MAS004491 RU 25-06

Rapid Update 777 Granturismo Folgore – Internal pillar trim replacement

DATE: April 2 2025

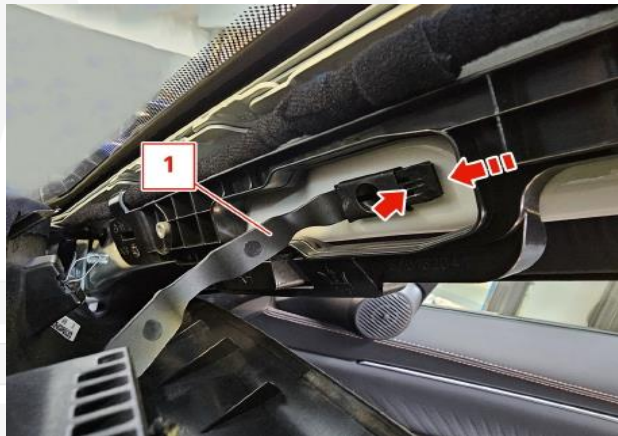
3. Make sure you use all the interior protection/precautions to work inside the vehicle.
4. If the VIN list states to replace the A-pillars, both front side trims must be replaced, following the procedure in the workshop manual:
 - a. **9.44.001 RH WINDSCREEN PILLAR COVER.** Removal-Refitting or Replacement
 - b. **9.44.002 LEFT WINDSCREEN PILLAR COVER.** Removal-Refitting or Replacement
5. Perform the operation on **both sides of the vehicle (Driver side and passenger side).**

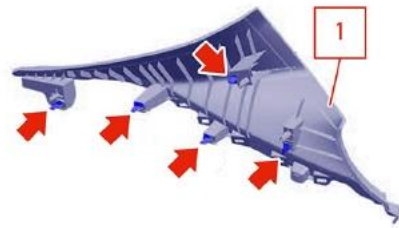
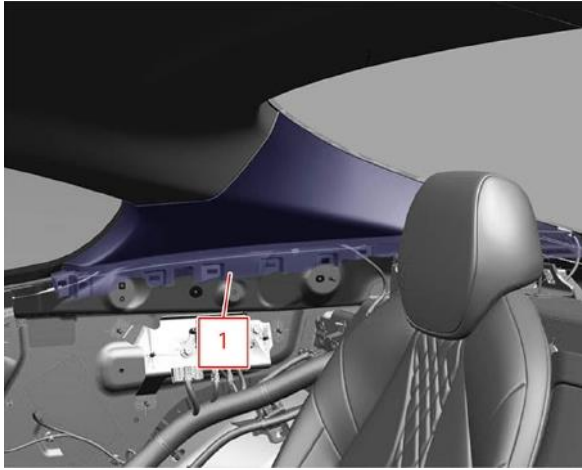
6. If **only the replacement of the front pillars is planned**, the procedure is concluded and the vehicle can be approved, otherwise continue with the **replacement of the rear pillars**.
7. To replace the C-pillar, follow the procedure given in the workshop manual:
 - **9.44.007 REAR PILLAR PROTECTION COVER RH.** Removal-Refitting or Replacement

▪ 9.44.008 LEFT REAR PILLAR PROTECTION COVER. Detachment-Reattachment or Replacement
